STATE OF CALIFORNIA
STATE WATER RESOURCES CONTROL BOARD

In the Matter of the Petition of Santa)
Ynez Community Services District on)
Behalf of the Solvang Municipal Improve-)
ment District Requesting State Board)
Consideration of Grant Funding of Con-)
veyance Facilities Associated With)
Project No. C-06-1108.)

ORDER NO. WQG 76-22

Order No. WQ 76-22

Fig. 1. Alternative Plans

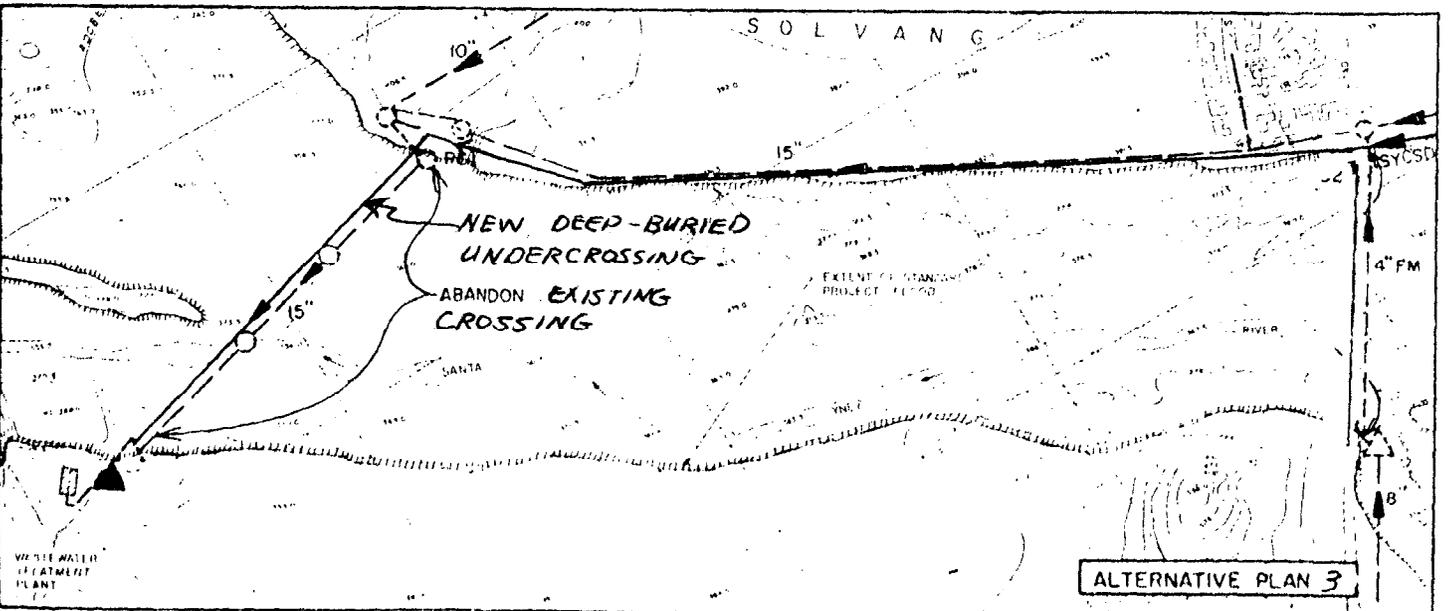
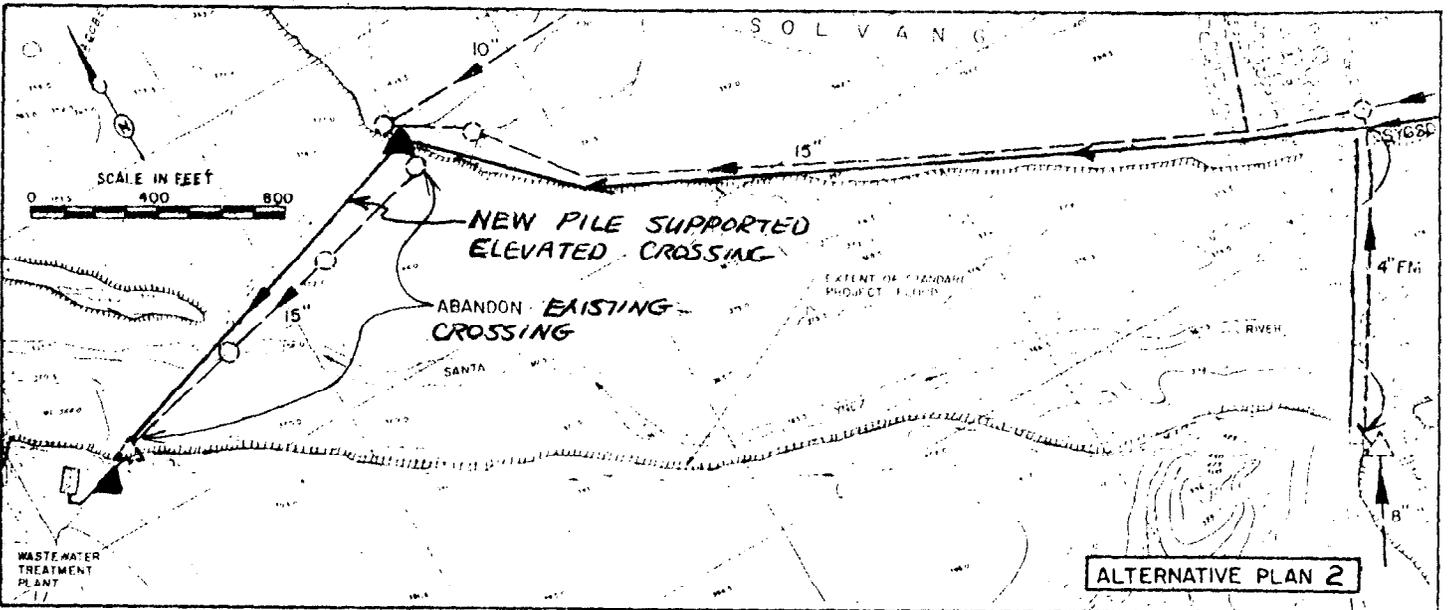
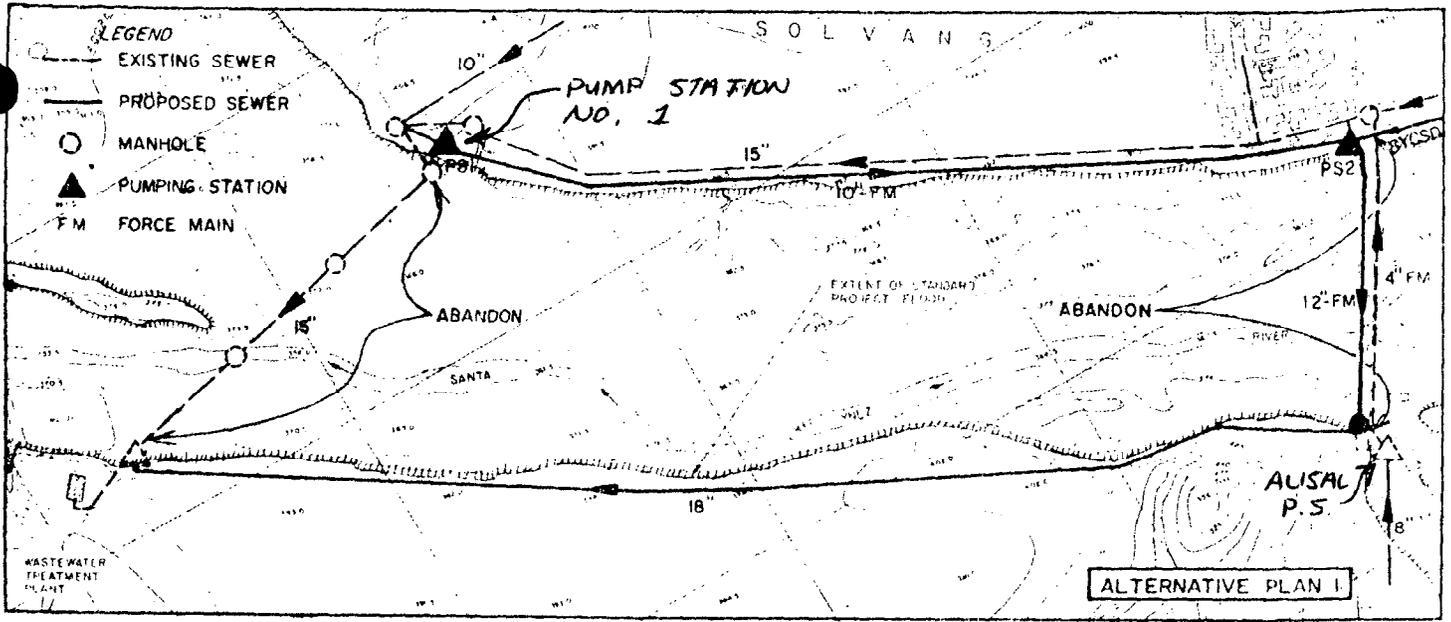
Three methods of jointly crossing the river were considered to be viable possibilities. One alternative requires attaching the sewer to an existing structure, the Alisal Bridge. Since a significant portion of Solvang's wastewater is conveyed to a point downstream of the bridge, Solvang would have to pump its wastewater back up to the bridge for crossing. A second possibility involves constructing a pile structure which would cross near the existing riverbed crossing. The third alternative requires constructing a new gravity sewer sufficiently deep in the riverbed to prevent washout.

Petitioner contends that the most cost-effective solution to the water quality problems in the Santa Ynez-Solvang region is a deep gravity sewer crossing which would run roughly parallel to, but deeper than the existing interceptor. Petitioner's contention is based on factors such as reliability, visual impact, and conservation of energy resources as well as monetary costs. The Division of Water Quality contends that the Alisal Bridge crossing is the most cost-effective solution to the water quality problems of both communities, based on a consideration of factors similar to those cited by the petitioner.

We have reviewed and considered all of the above factors in coming to our decision on the issues raised by this appeal. After analyzing the contentions of both petitioner and staff as to the most cost-effective means of crossing the Santa Ynez River, we have concluded that the Alisal Bridge crossing is the most appropriate alternative. This does not preclude petitioners from analyzing further other alternatives at their own cost. However, unless there is a modification of this order by the Board on further demonstration by petitioners within the time schedule set out by the Regional Board, the grant funding will be given only if the Alisal Bridge alternative is constructed.

1. The Alisal Bridge alternative is the most cost-effective solution to the river crossing problem.
2. The force main and pump station which would deliver Solvang's wastewater to the bridge is not an interceptor, as that term is defined in grant regulations.
3. The jointly used portions of the river crossing facilities are grant fundable to the 20 year capacity of both communities under Section 2108(e) of the grant regulations.
